APP/16/00921 - Dolphin Quay, Queen Street, Emsworth

Further to my letter dated 7/05/19, I note the email 16/05/19 from the Agent, and revised drawing 27958-PD109/C regarding levels in regard to the discharge of Condition 3.

Figure 14: Section in plane perpendicular to the affected window wall

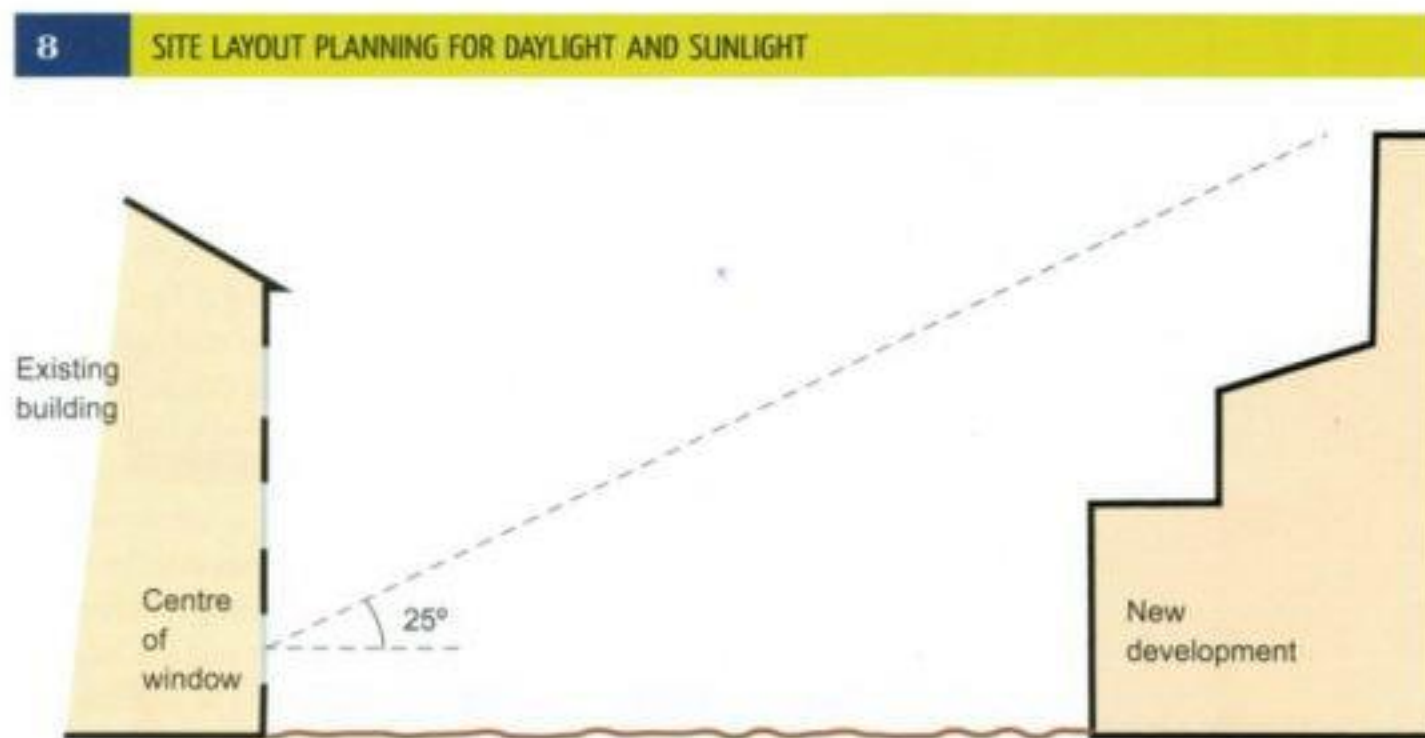
1. The roof pitch of the townhouses has been increased slightly over that shown on the approved drawings, moving the ridge northwards and reducing daylight to Queen Street, and the properties opposite. I would note the 25° line shown regarding daylighting provision on the application drawings is shown emanating from the head of the GF windows to the properties opposite. This is incorrect, and BRE's "Site Layout Planning for Daylight and Sunlight – A Guide to Good Practice" 2nd Edition, 2011" shows how it should have been taken from the centre of the window, see below.

This means that any further incursion on the lighting to the properties opposite should be resisted, and the applicant should build to the approved drawings (Condition 3).

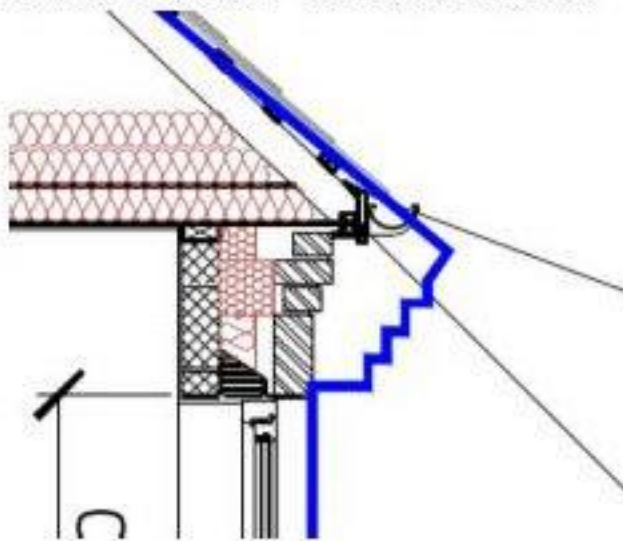
3. The applicants overlay of the outline of the approved section over the construction drawing suggests that the generous eaves detail shown on the approved drawings is being replaced by shallow imitation - see extract below:

The impact this will have on the street elevation cannot be under estimated. The substantial stepped eaves shown on the approved drawings and the seen in the artistic impression included in the Design and Access statement provides an attractive junction between wall and roof. The pale imitation now being shown is inadequate and will diminish the elevational quality of the townhouses to that of standard developer fare, well short of the aesthetic standard required by the unique historic context of the site. It would of course be a further breach of Condition 3.

Client	Scale 1:100	Drawn
Job Title Dolphin Quay Boatyard	Date 23.05.19	Sheet Size A4
Drawing Title Comparison of section with approved elevation	Drawing Number 2001	Revision P1

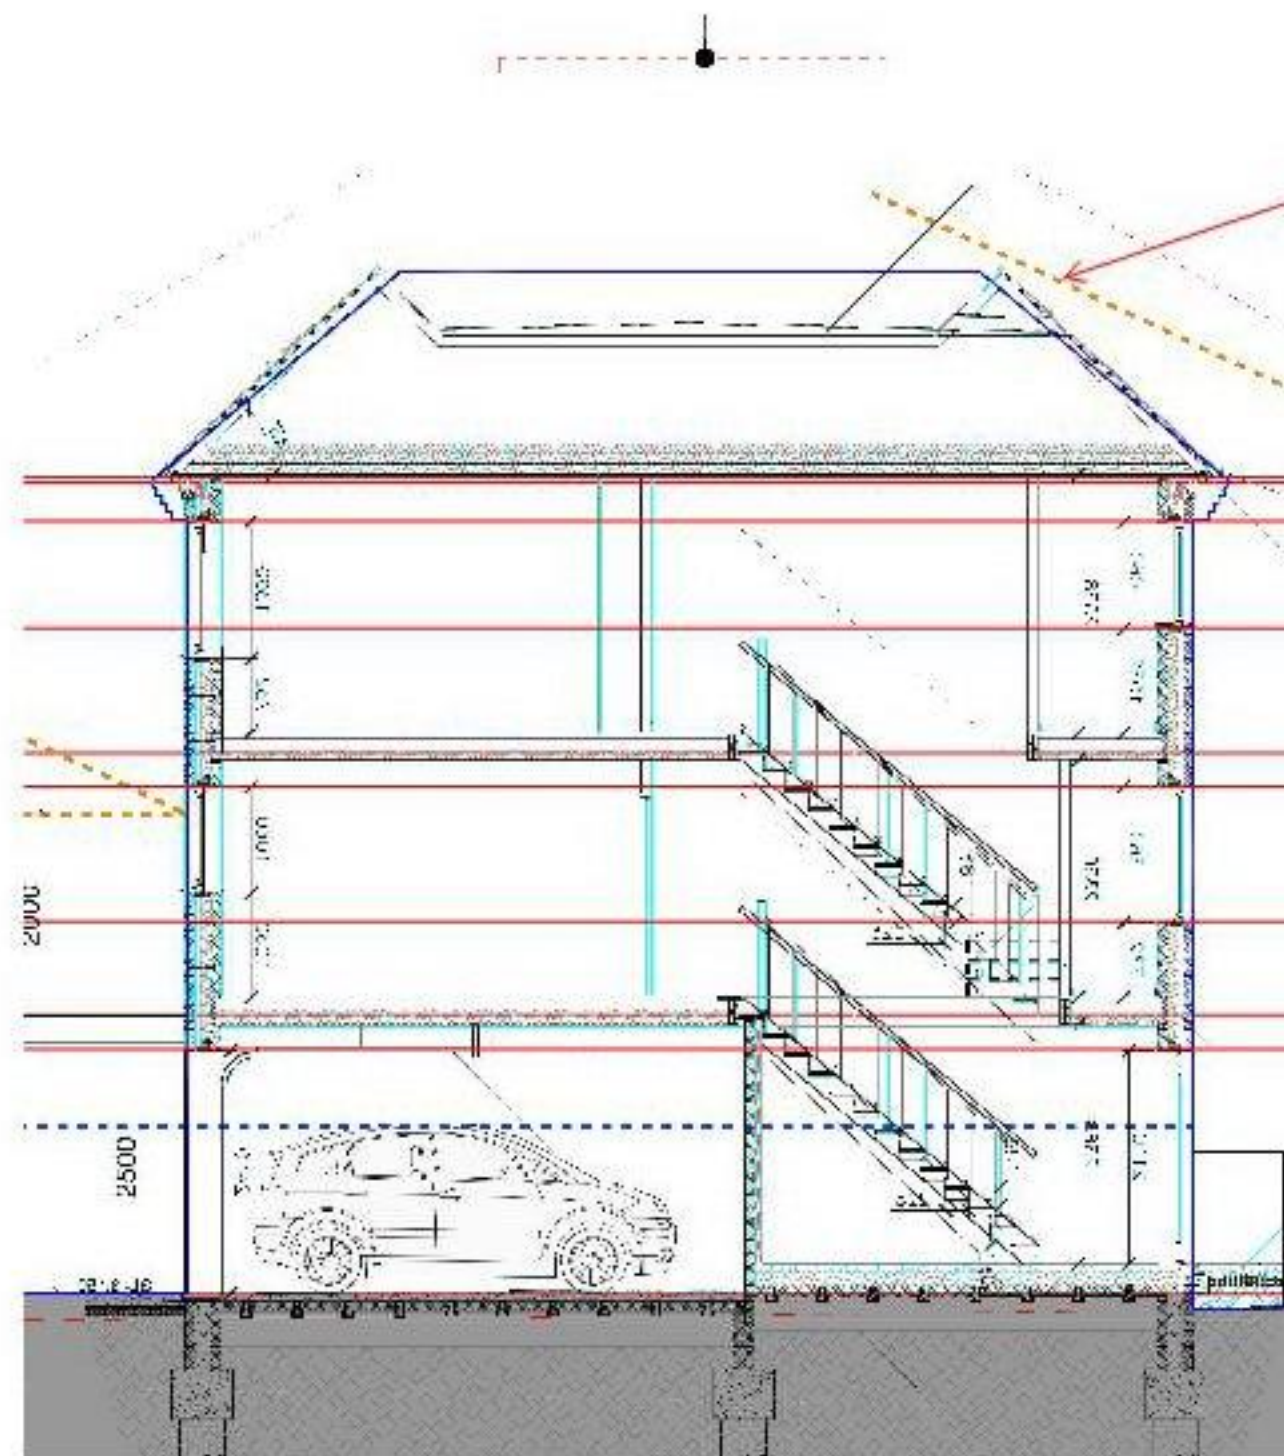
In this case however, the revised drawing will impact on the street elevations, as the head height for the front doors, and presumably the windows, is shown to be significantly lower than that shown on the approved elevation (please see attached drawing I405/2001/PI).

This reduction in height of the GF windows would make the elevation far more pedestrian than it already is, and would breach condition 3 requiring the applicant to build to the approved drawings. I note that window hierarchy was specifically referenced in the Design and Access statement (see adjacent) as an important elevational feature and I cannot therefore understand why it should now be considered to be less important.

25 degree line taken from head of GF windows opposite.
This is incorrect - should be from centre of window
